Subject: RECALL 06V-151- Minotour - Braun Lift Floor Reinforcement

MODEL: MINOTOUR
SUBJECT: BRAUN LIFT FLOOR REINFORCEMENTS
PAGE: 1 OF 2

Figure 1

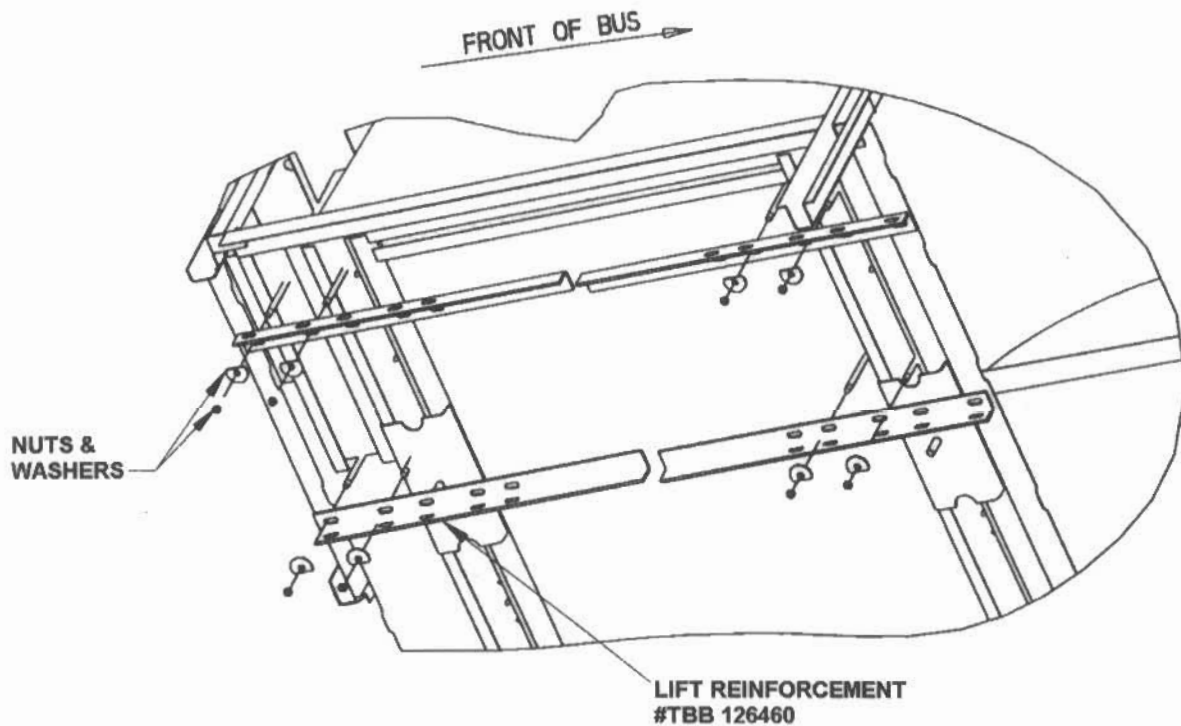
1. Secure unit to prevent rolling.
2. Remove eight (8) fasteners holding the platform down. Remove all nuts and washers and discard.
3. Clean area where reinforcements are to be installed.
4. Install the four (4) Lift Reinforcements, part #TBB 126460 using eight (8) Nuts, #TBB 27120377 and Lock Washers, part #TBB 27120381, and Flat Washers, #TBB 27446363. **Fig 1**

Note: Fig. 1 is the primary installation. If this installation IS NOT possible, see Fig. 2.

REINFORCEMENTS MUST BE ATTACHED TO FLOOR CROSSMEMBERS.
REINFORCEMENTS CAN BE CUT TO FIT PROPERLY.

Figure 2

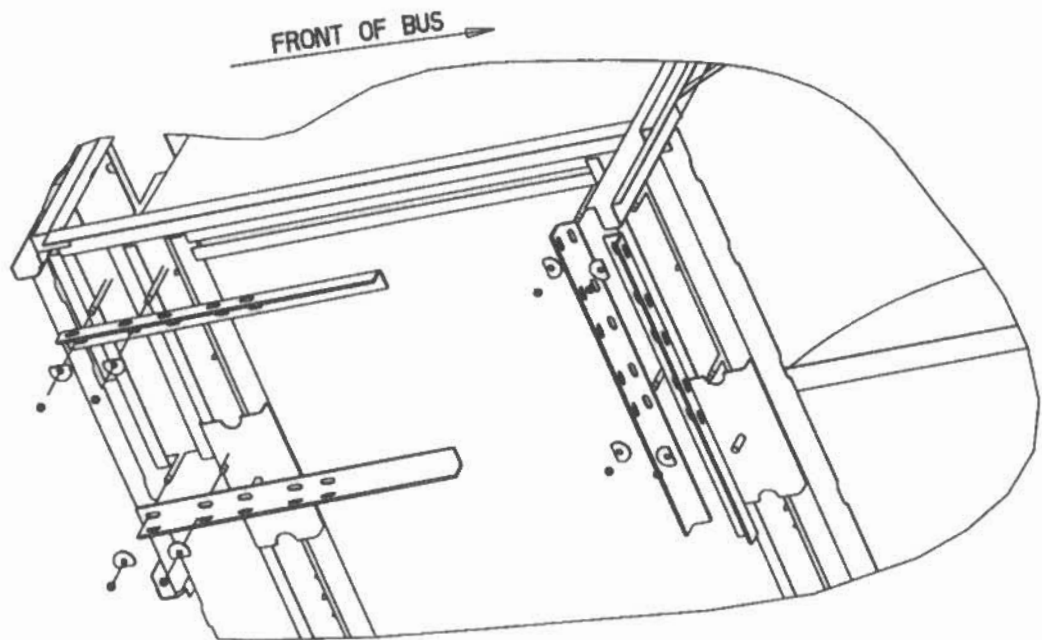
ALTERNATIVE INSTALLATION
THIS INSTALLATION IS TO BE USED ONLY WHEN
THE PRIMARY INSTALLATION IS NOT POSSIBLE.
